Surface Water Drainage Technical Note		
Project Name & Number:	Condair, Brookside Avenue	D2287
Subject:	Surface Water Drainage Technical Note	
Client:	Condair Ltd	
Prepared by and Date:	S Burnett	07/05/2025
Planning Reference:	R/239/24/PL

BP Civils has been instructed by Condair Ltd to prepare a surface water drainage technical note in view of the objection raised by Arun District Council's drainage engineers, in respect of the above planning application.

APPENDIX A – Arun District Council Drainage Consultation Comments

Application Reference:	R/239/24/PL	Reviewer Reference:	ADC/SB
Planning Officer:	Harry Chalk	Date of Review:	10/04/2025
Site Name:	Condair Building Artex Avenue Rustington BN16 3LN		
Application Description:	Demolition of existing building (facing Brookside Avenue) and redevelopment of the rear of the site for office use, with ancillary storage facilities and landscaping falling within Class E. This application is in CIL Zone 4 and is zero rated as other development.		
Assessment Number:	1 of 2

Drawing No. 000-BPC-WD-ZZ-D-C-PL500 Rev. A

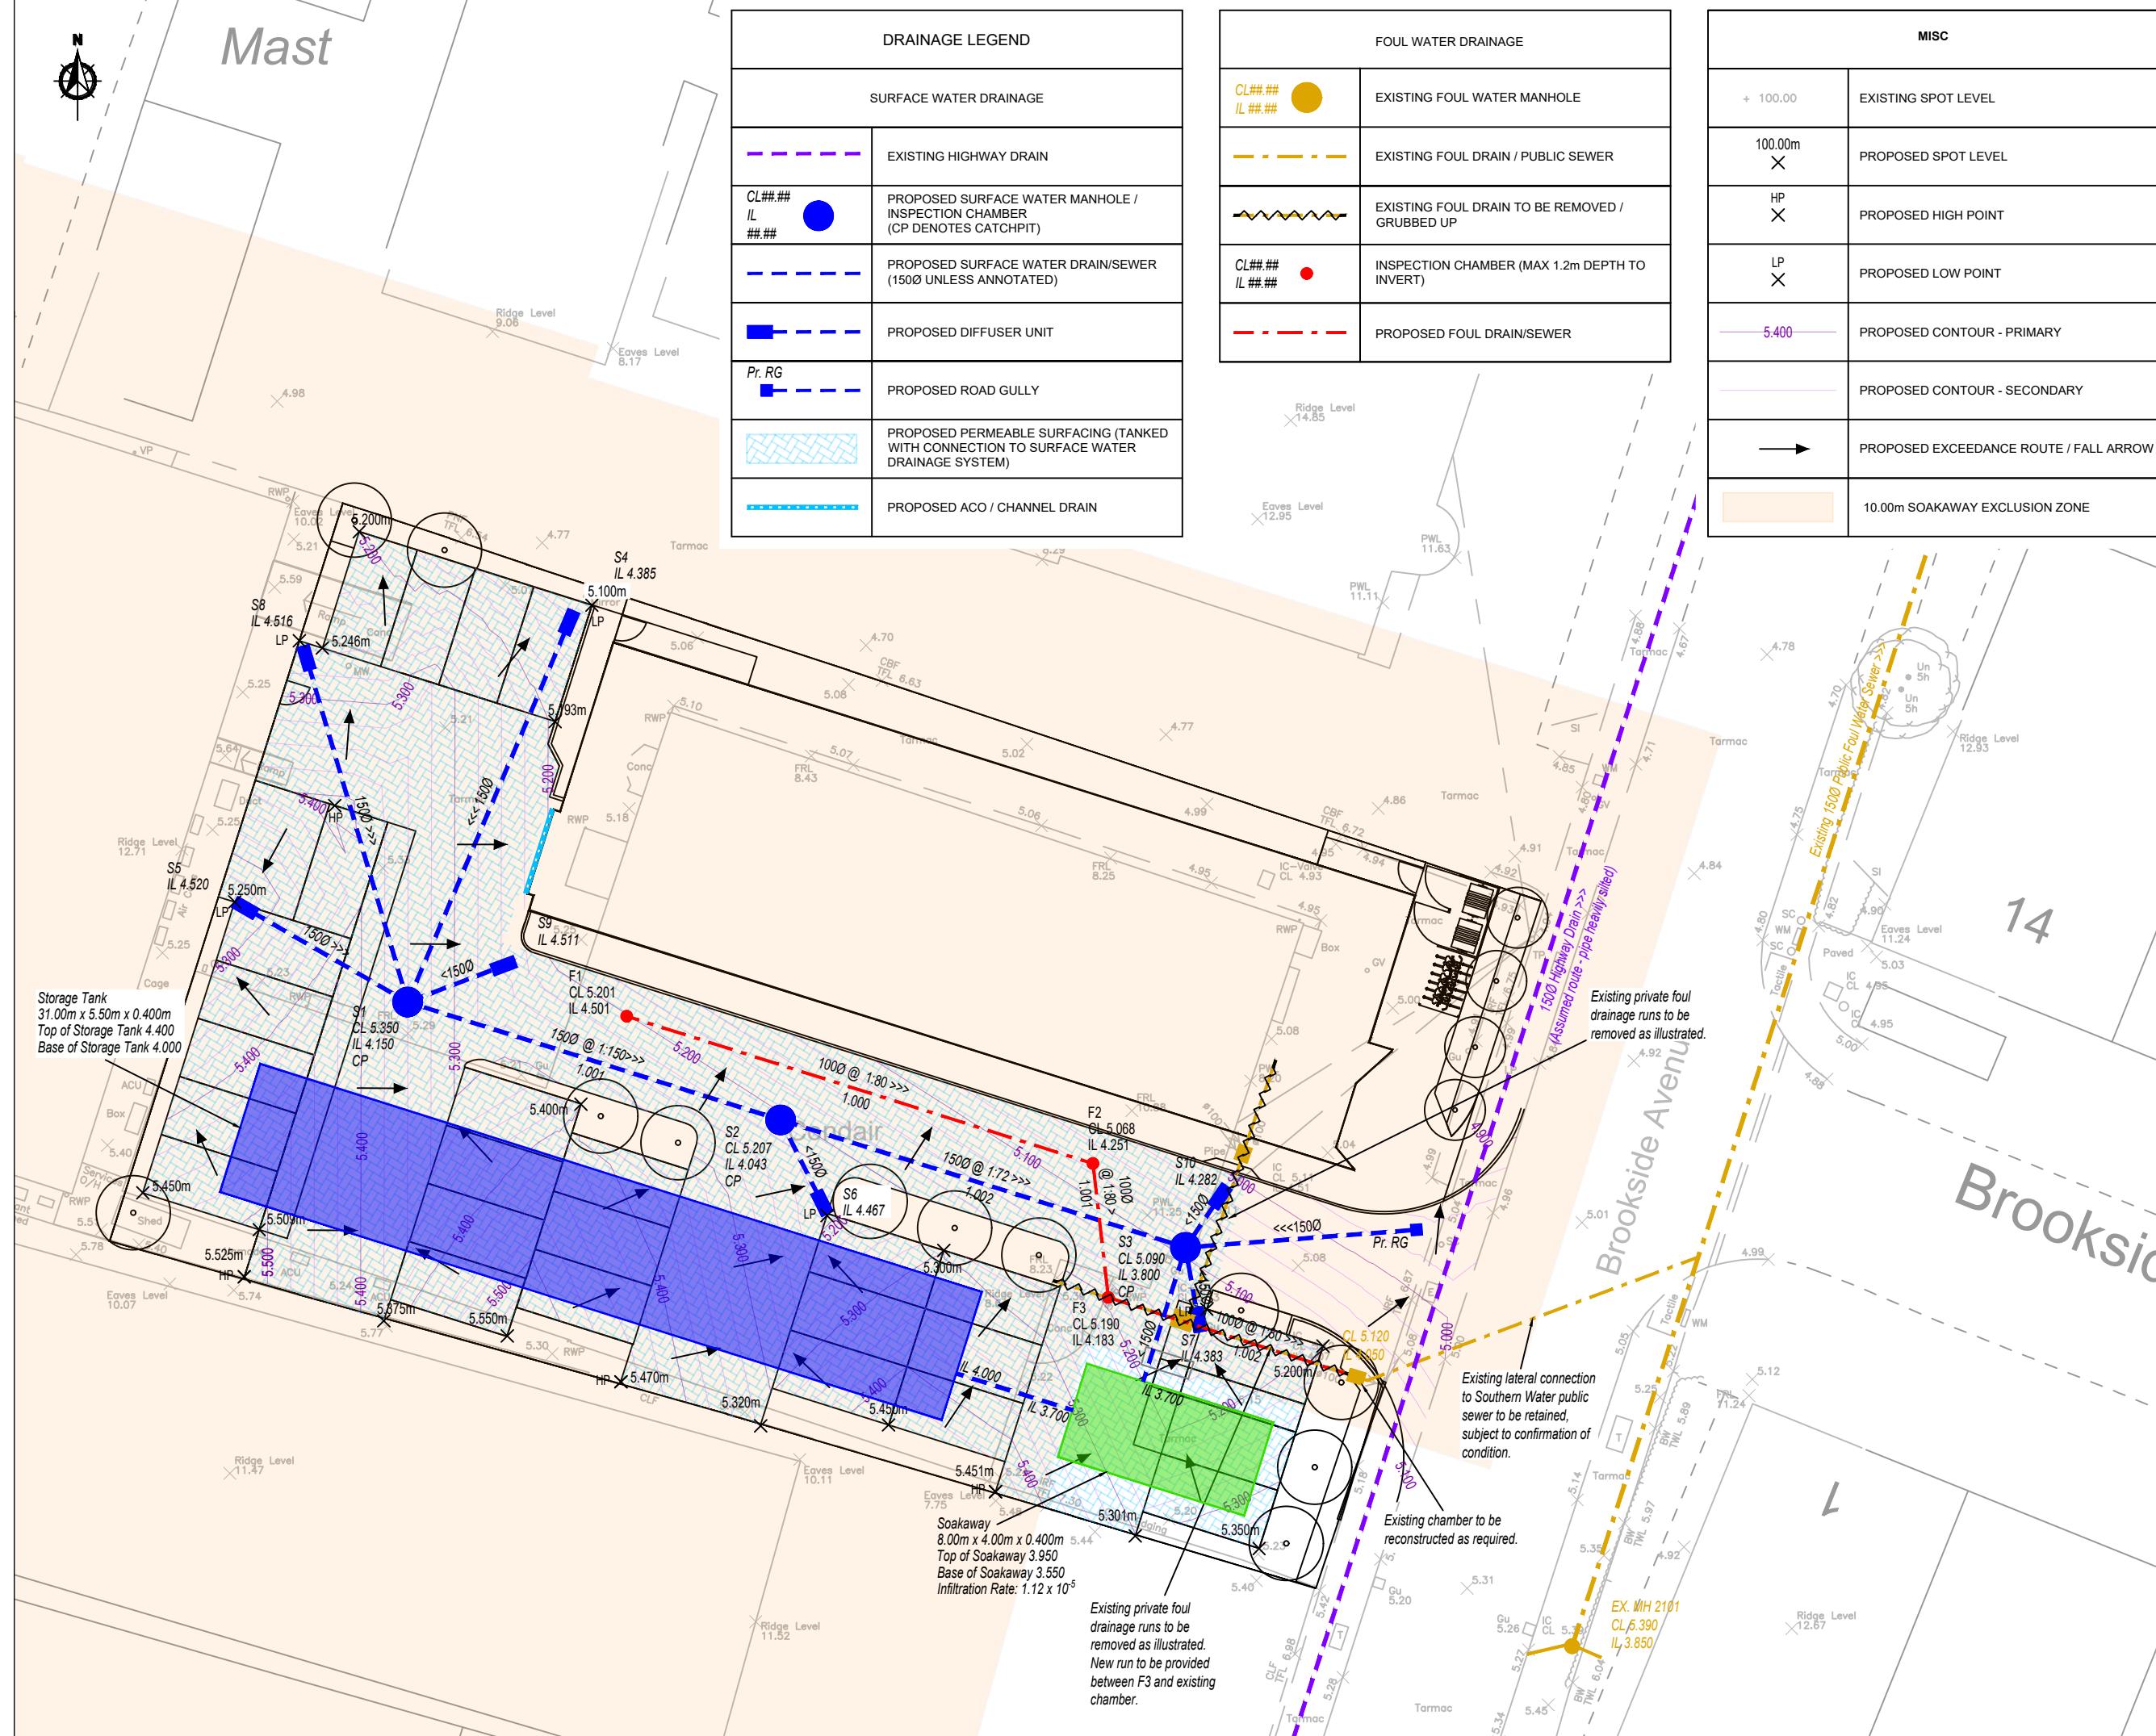
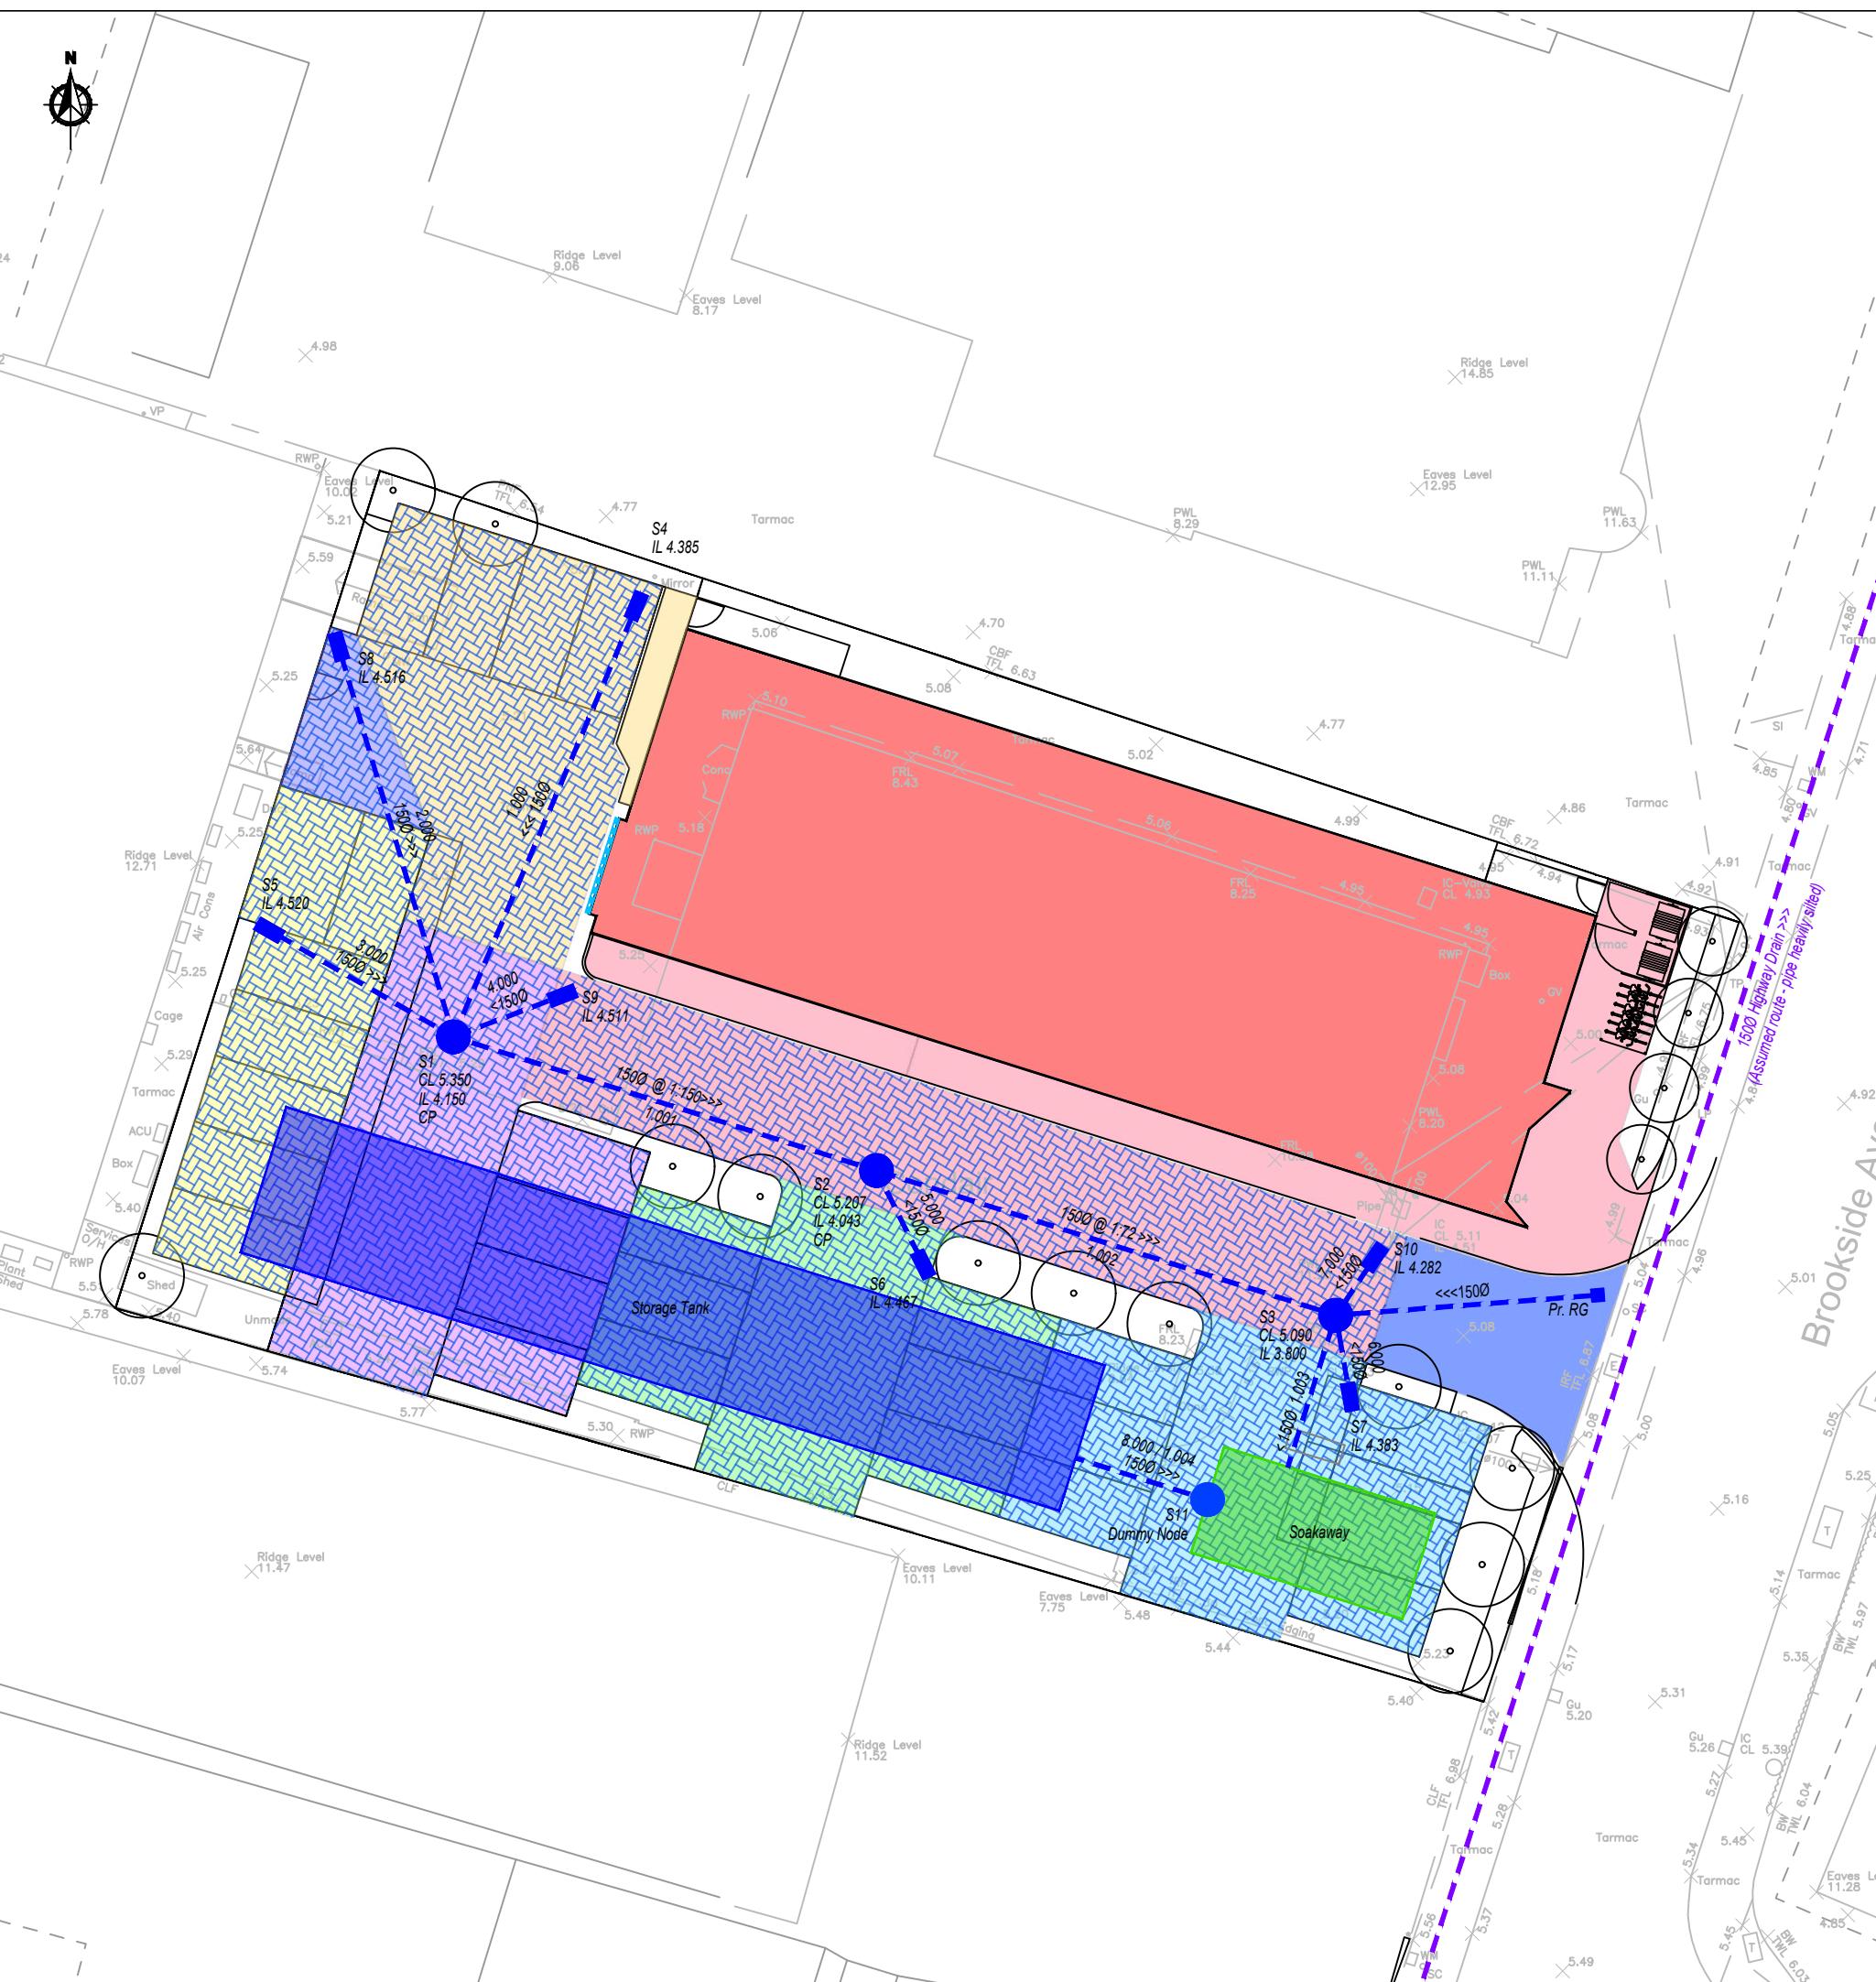
BP Civils has been unable to reach an agreement with West Sussex County Council to permit post-development surface water flows to discharge to the highway drain beneath Brookside Avenue, as was originally proposed. This is despite it being acknowledged and accepted that the evidence provided as contained within the Flood Risk Assessment and Drainage Strategy (D2287/FRA1.2, July 2024) confirms that flows from the site, as existing, drain to both this highway drain and also Southern Water's public foul water sewer, also beneath Brookside Avenue, and that the strategy proposed presented significant betterment compared with the existing drainage arrangements.

The surface water drainage strategy has been re-assessed in view of site constraints and a revised proposal is included within this technical note (drawing **PL500 Rev. A – 'Proposed Drainage Strategy'**).

The revised surface water drainage strategy will rely on infiltration, with a soakaway positioned in the south-eastern corner of the site. This location is the only viable location for a soakaway on site, given that soakaways must be positioned at least 10.00m from existing and proposed structures given the influence of the underlying chalk strata.

The proposed soakaway measures 8.00m x 4.00m x 0.400m, providing a plan area of 32m² which sits entirely outside of the 10.00m 'exclusion zone'.

The proposed soakaway is positioned with the base at a level of 3.55m AOD, which is 1.75m below ground level. The base of the proposed soakaway is therefore positioned c. 1.57m above the current peak groundwater level established in respect of the groundwater monitoring undertaken.

Given the limited available footprint to provide a soakaway in view of site constraints, an attenuation tank is provided upstream of the soakaway to provide storage beyond the capacity of the soakaway in view of the greater storm events.
